ADDENDUM NUMBER ONE (1)

Project: "The Commons" Buildings
Hinds Community College – Rankin Campus
Pearl, MS
HCC Bid #3307
PN: 24053

FROM: Dean Architecture, P.A.
661 Sunnybrook Road, Suite 140
Ridgeland, MS 39157
(601) 939-7717

Sheet Number: A111
DINING HALL FLOOR PLAN

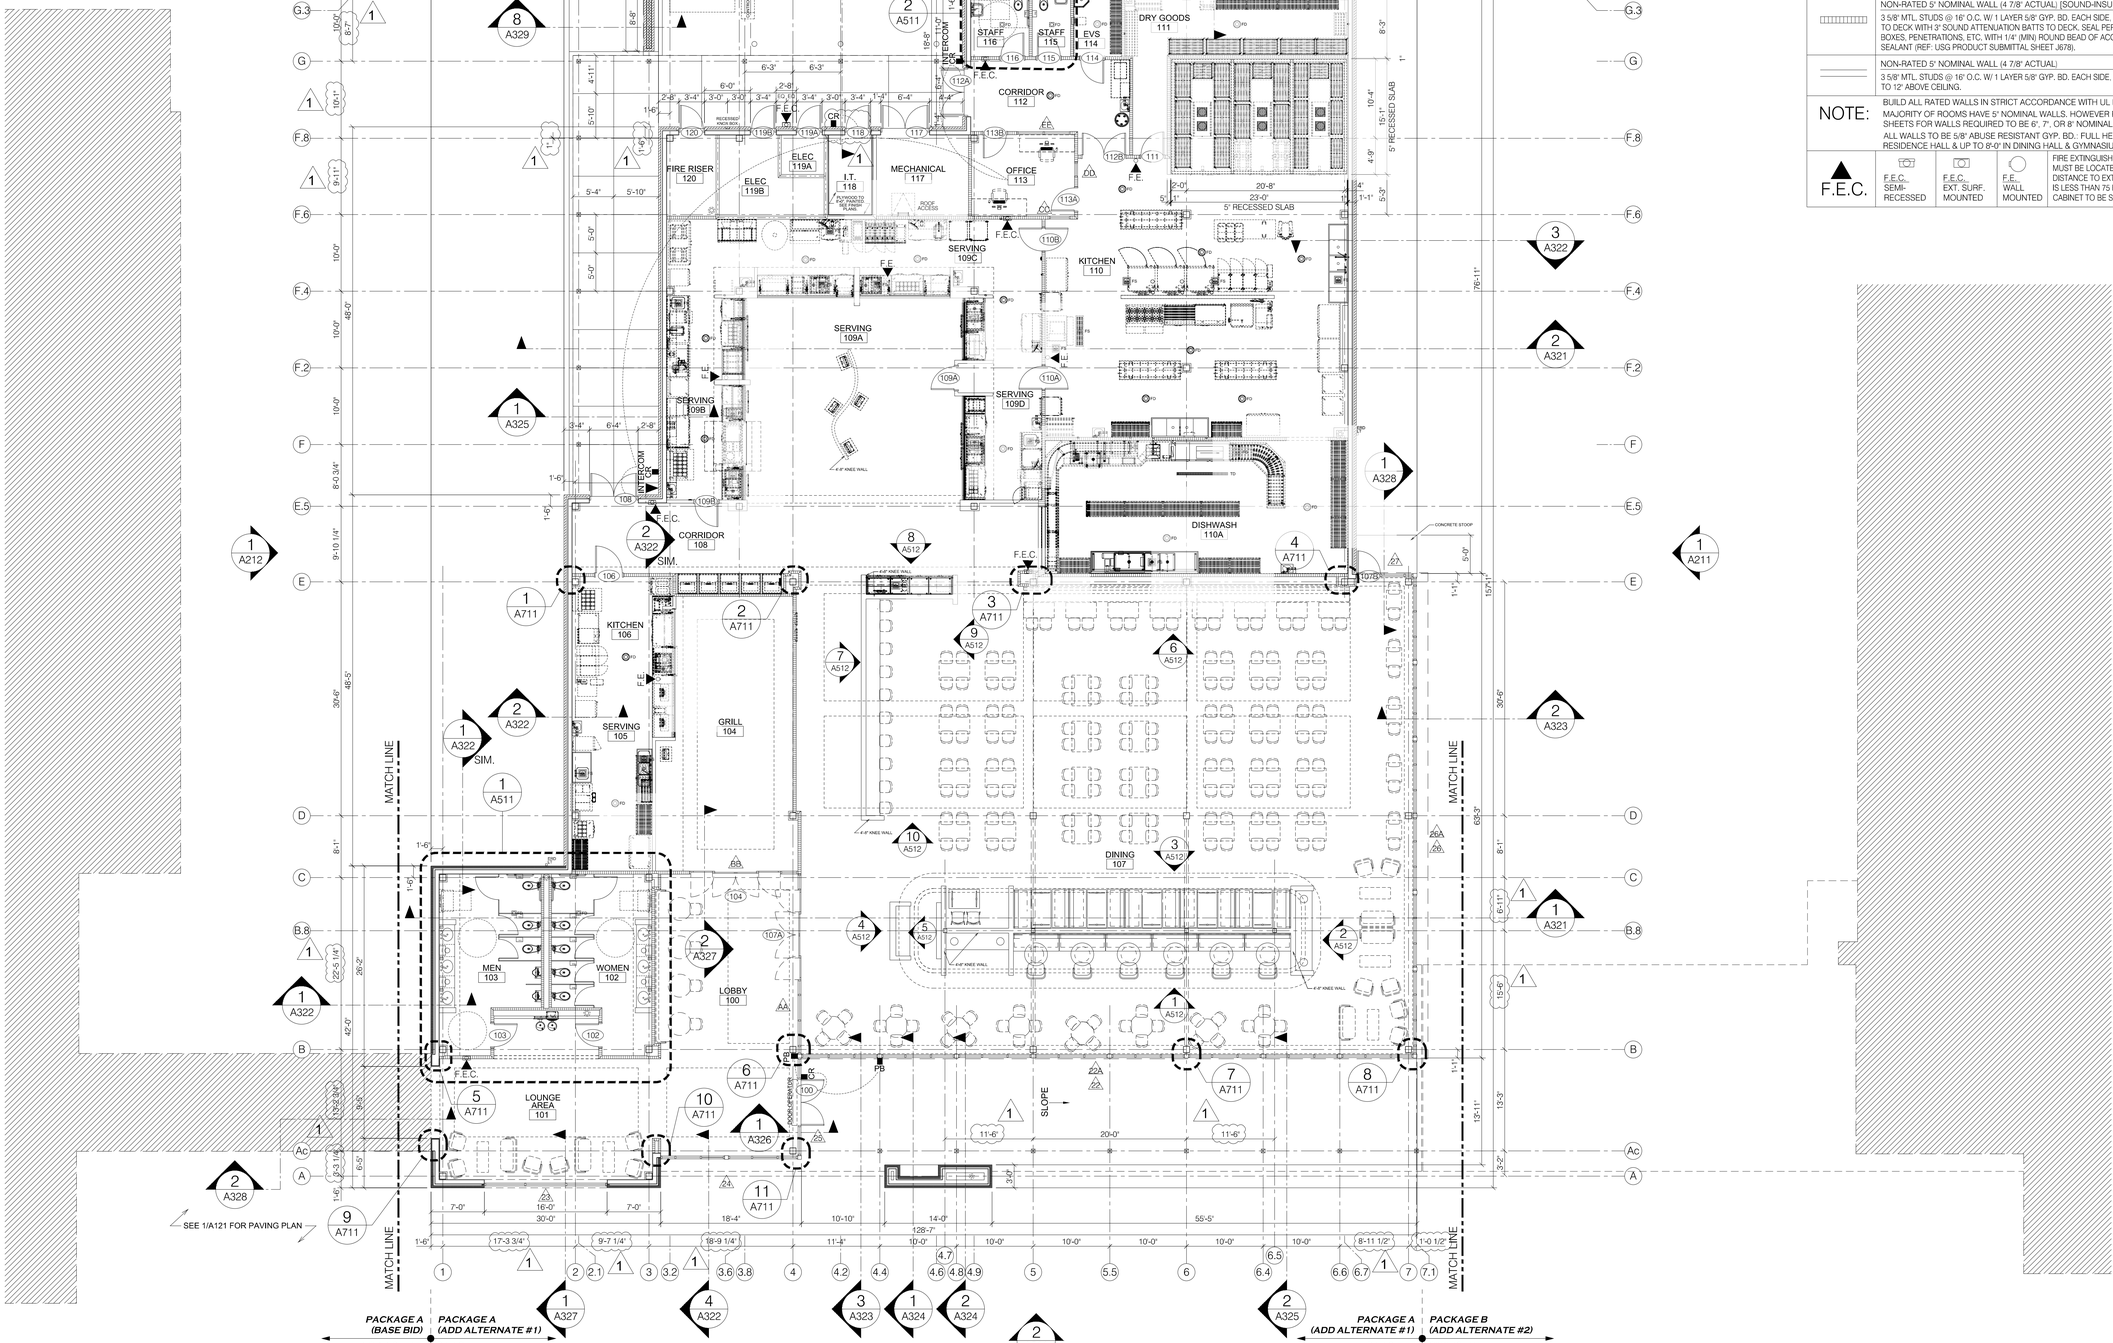
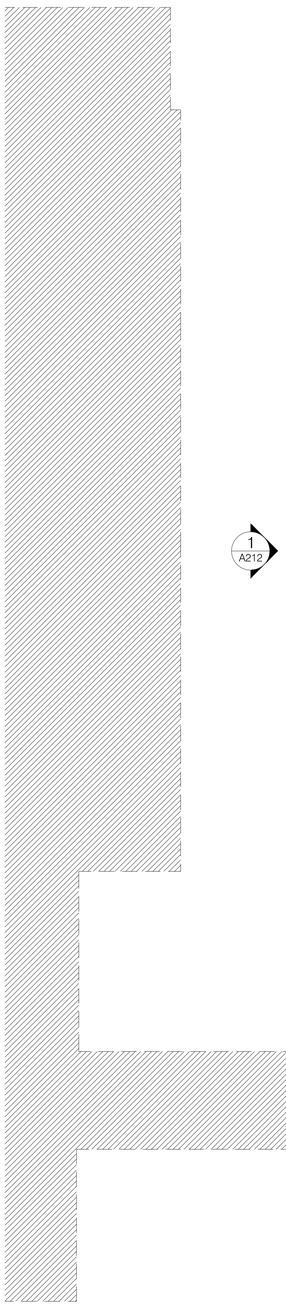
ITEM #5: SHEET A111 - DINING HALL FLOOR PLAN.
Remove existing sheet and replace it with revised sheet dated 9/30/2025.
Door 118 to I.T. Room 118 – Add Card Reader to this door and provide electrical rough in per detail 3/E400 on Electrical Drawings – Dimension Clarification per Structural.

Sheet Number:
A112
DINING HALL REFLECTED CEILING PLAN

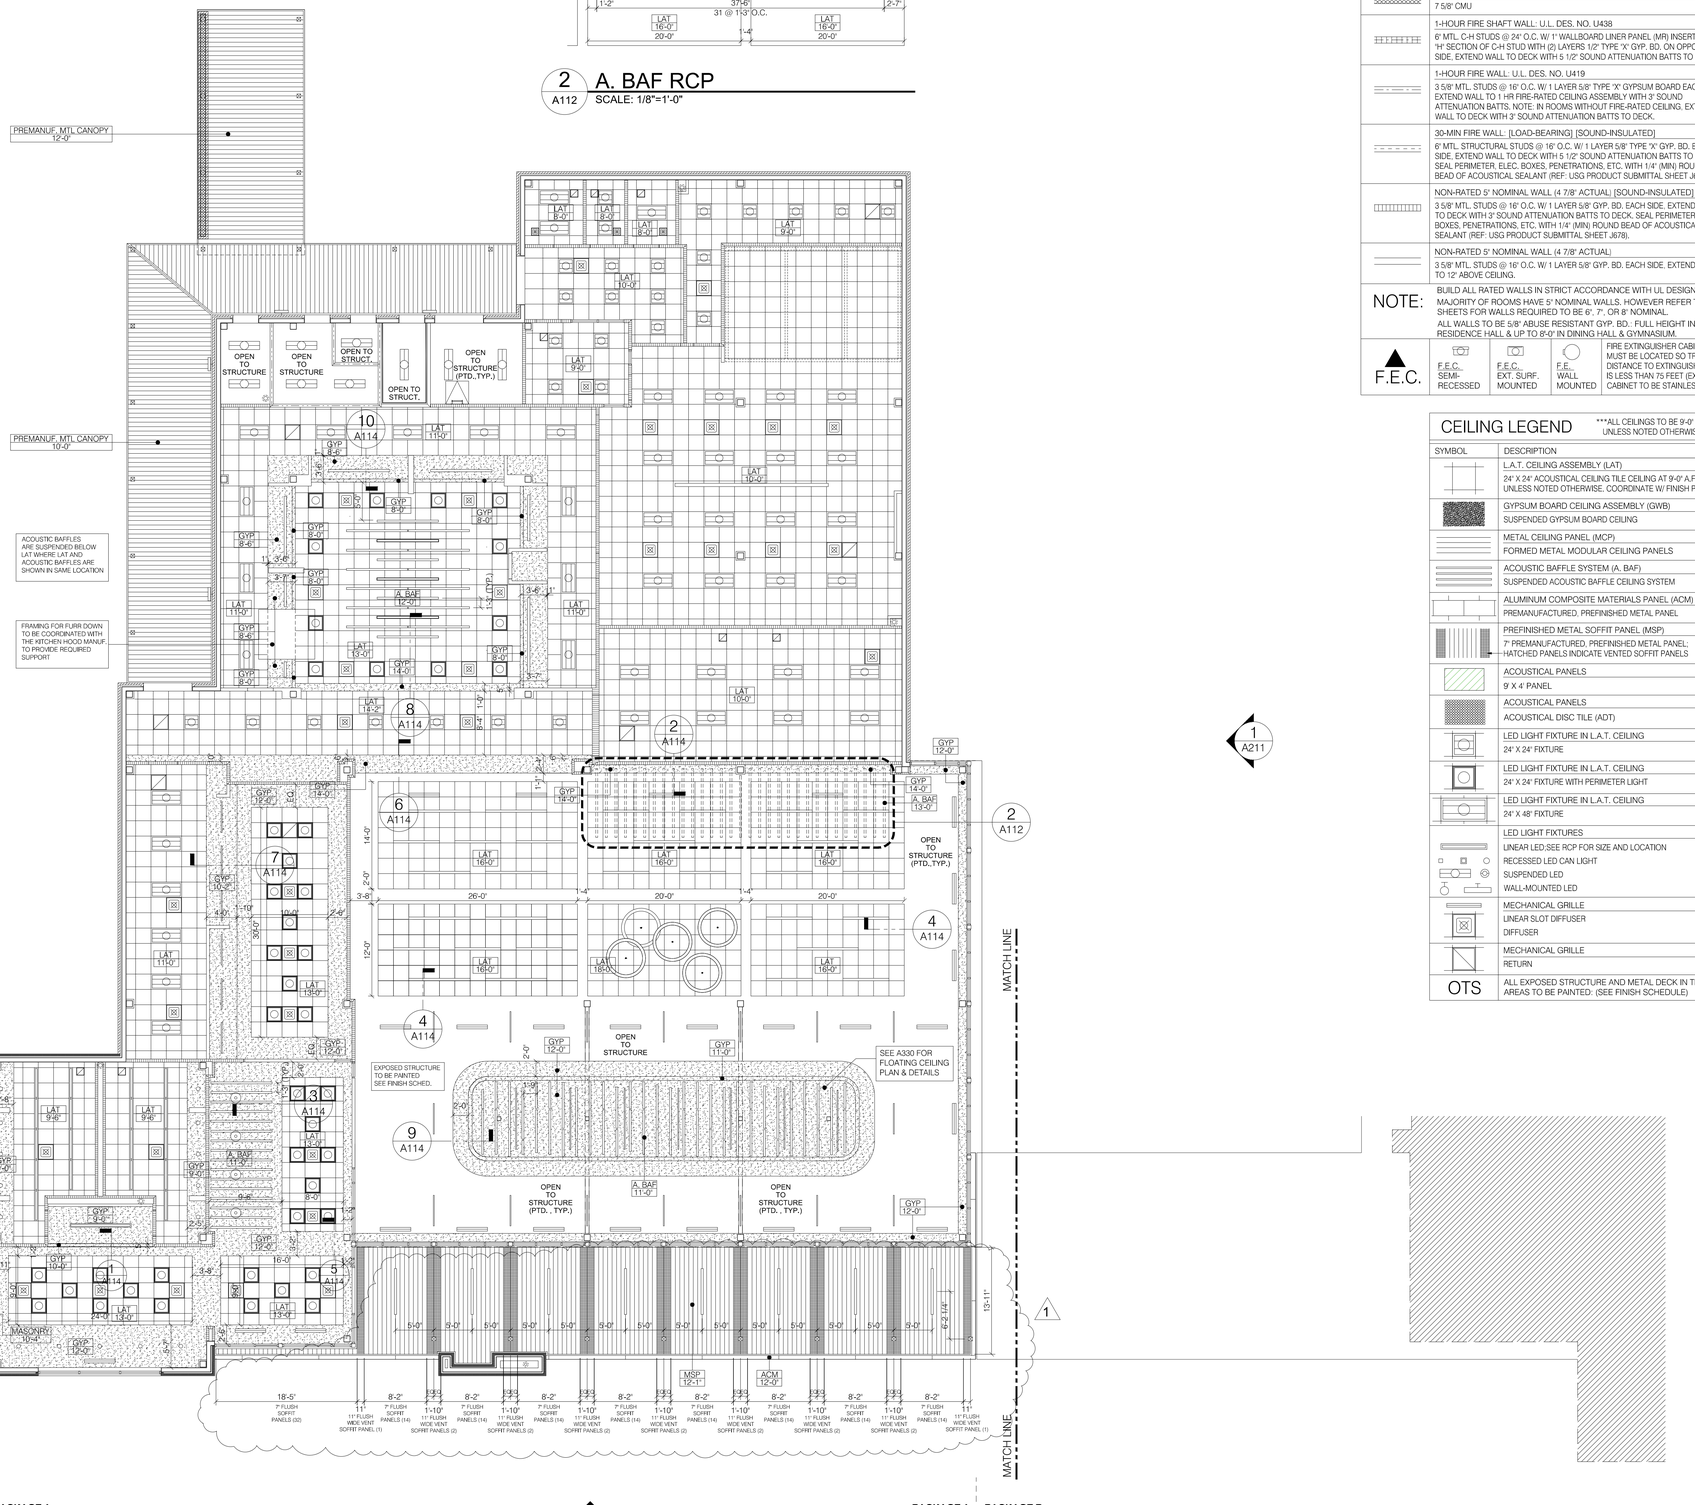
ITEM #6: SHEET A112 - DINING HALL R.C.P.
Remove existing sheet and replace with revised sheet dated 9/30/2025 – Dimension clarifications to soffit lights.

Sheet Number: 1
A113
DINING HALL ROOF PLAN

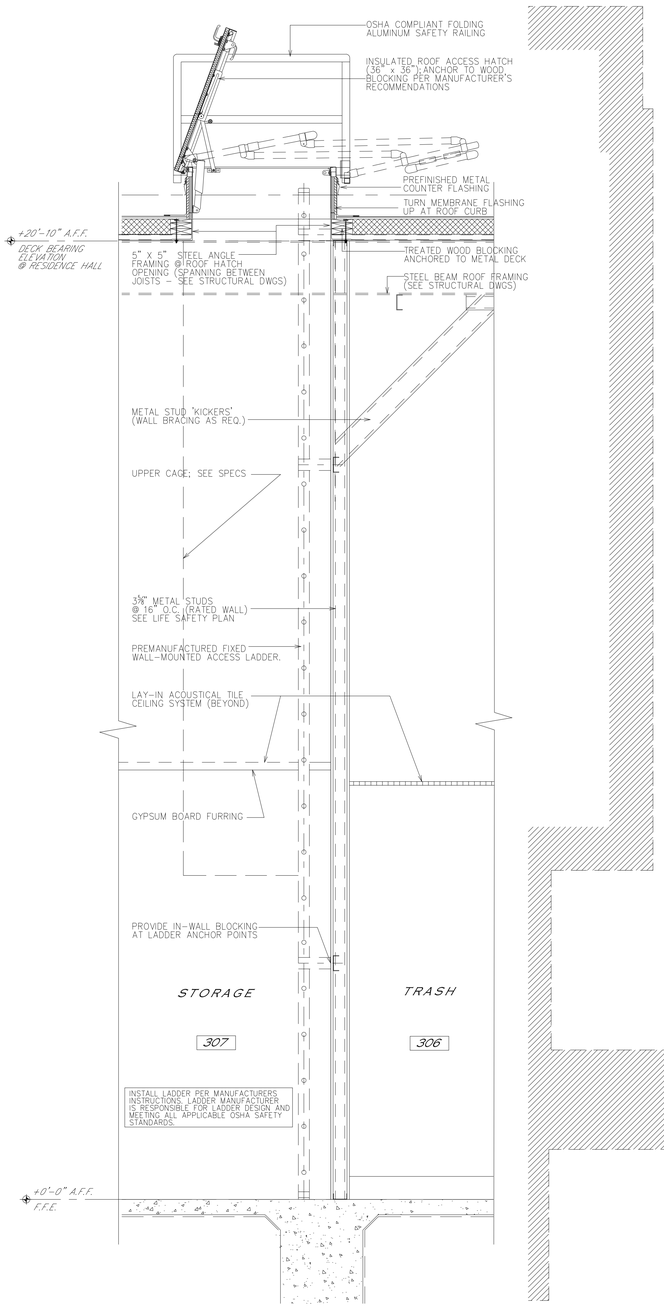
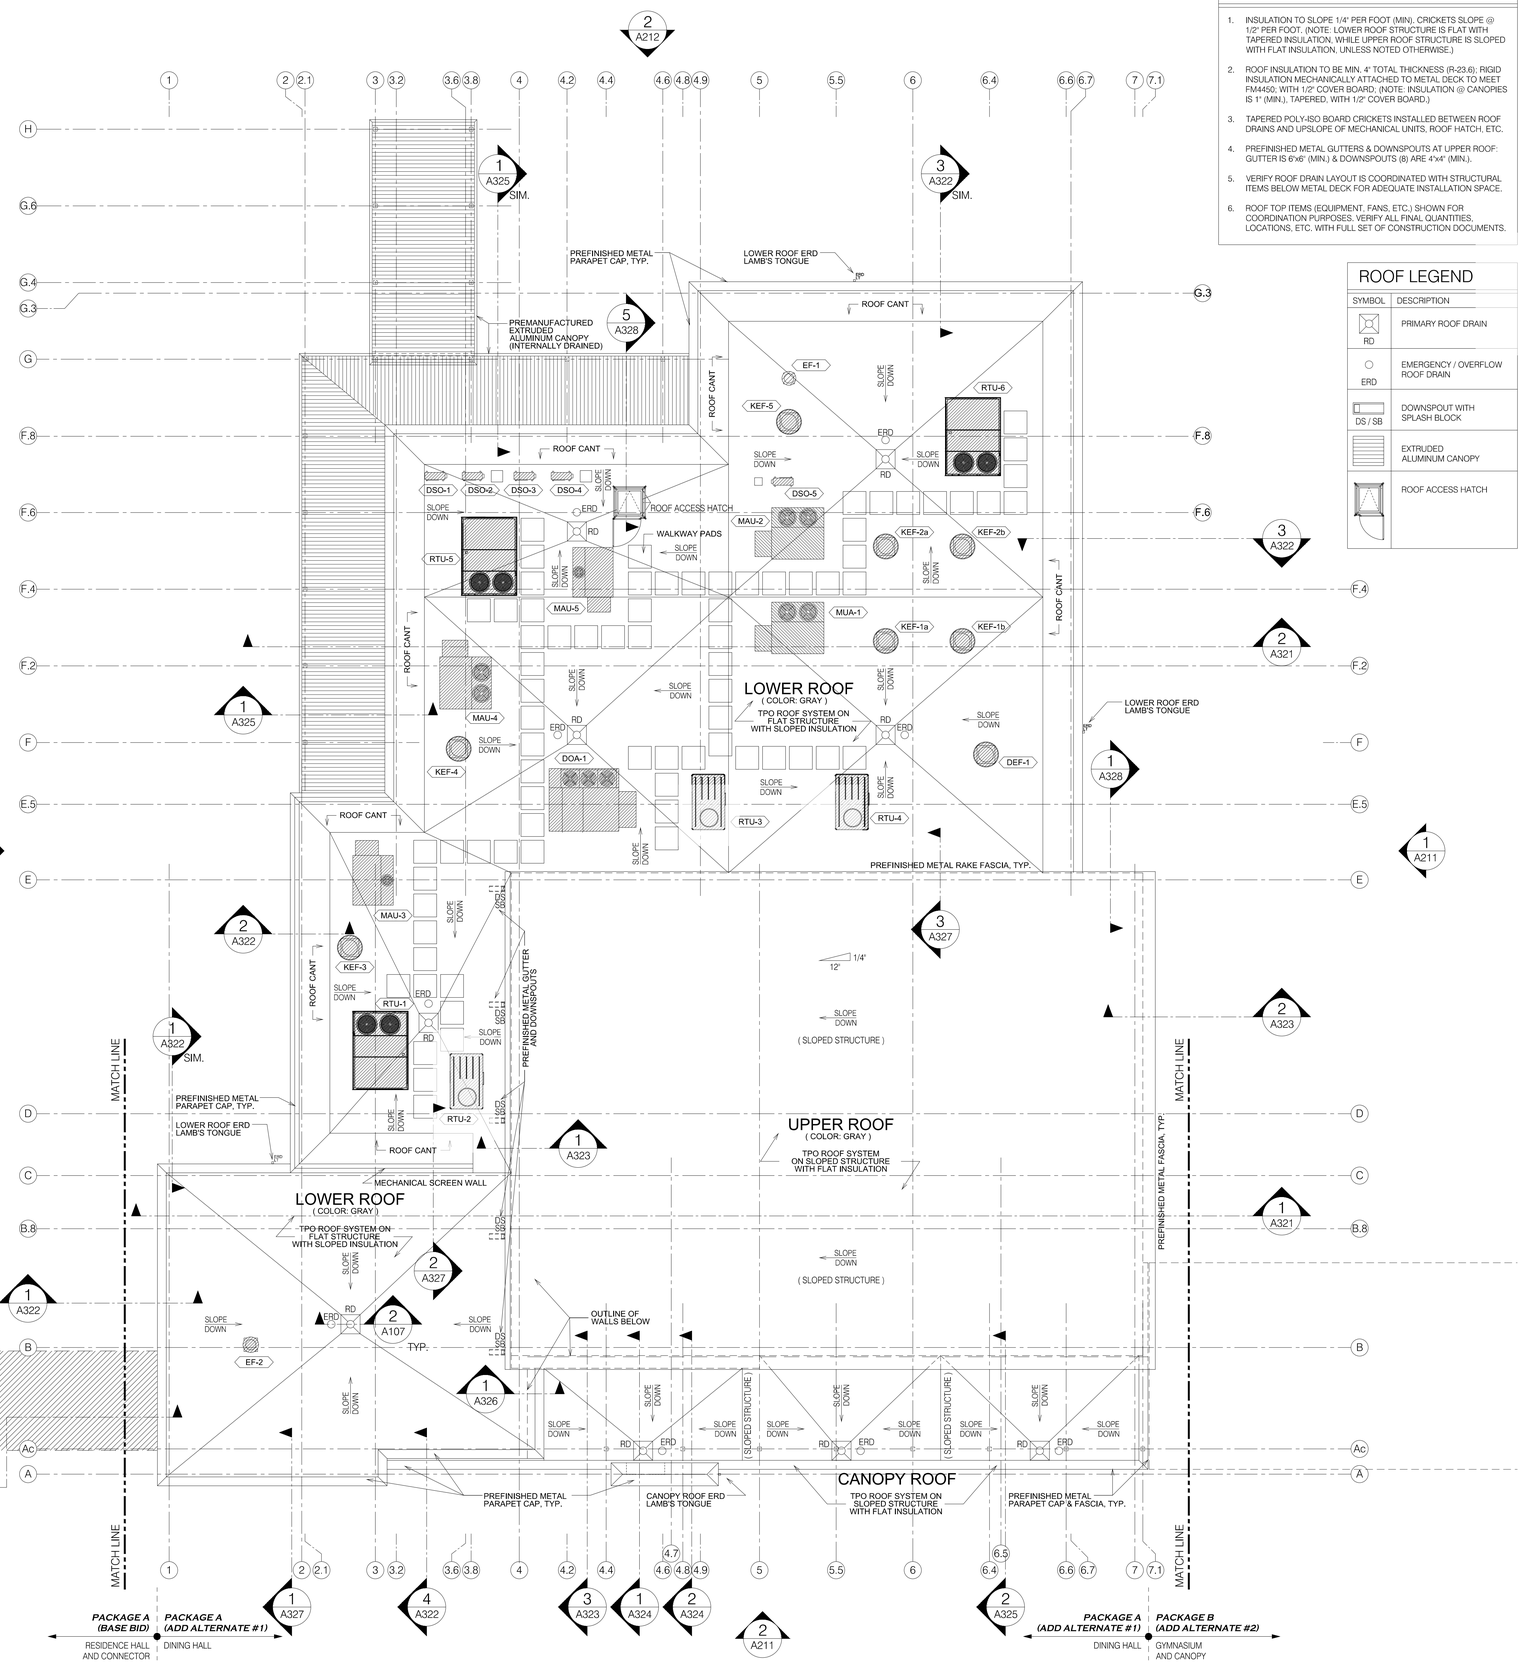
ITEM #7: SHEET A113 – DINING HALL ROOF PLAN.
Remove existing sheet and replace with revised sheet dated 9/30/2025 – Revised R.T.U. locations.

GYMNASIUM
LIFE SAFETY PLAN

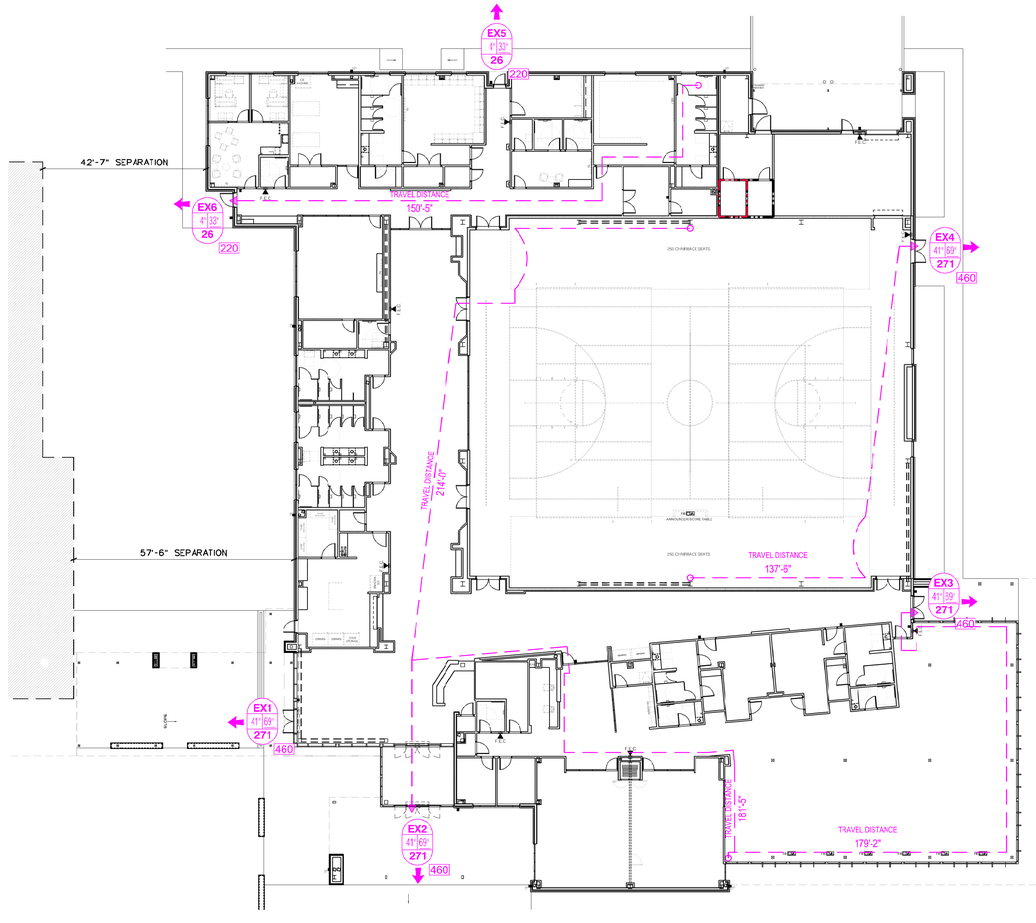
ITEM #1: SHEET LS101 – GYMNASIUM LIFE SAFETY PLAN
Remove the existing sheet and replace it with the revised sheet dated 9/30/2025.
Added State Fire Marshall 2024 IBC Code requirements.
